Technical Bulletin No. 134

S200 Pump Improvements

Date: February 25, 2020

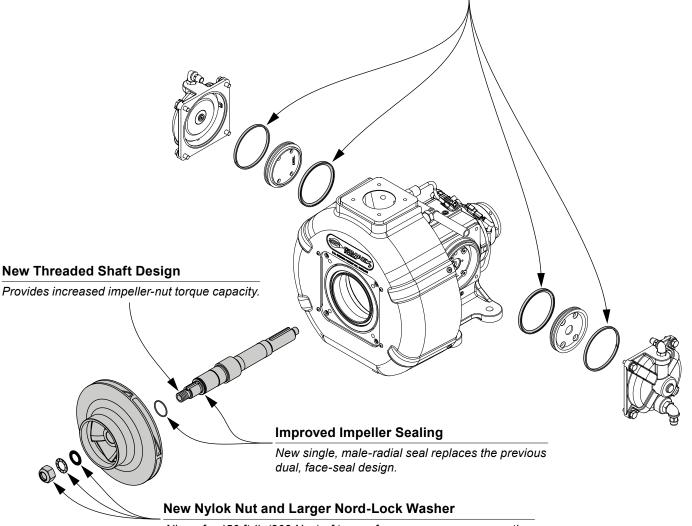
Beginning January 1, 2020, all S200 pumps shipped will include the following improvements: New piston-seal material and new energizer, new wear-strip material, and new impeller-nut locking design.

- Improved piston-seal and wear-strip material provides increased chemical resistance.
- New O-ring style energizer requires 50% less torque to prime the pump.

Allows for 150 ft-lb (203 N·m) of torque for a more secure connection.
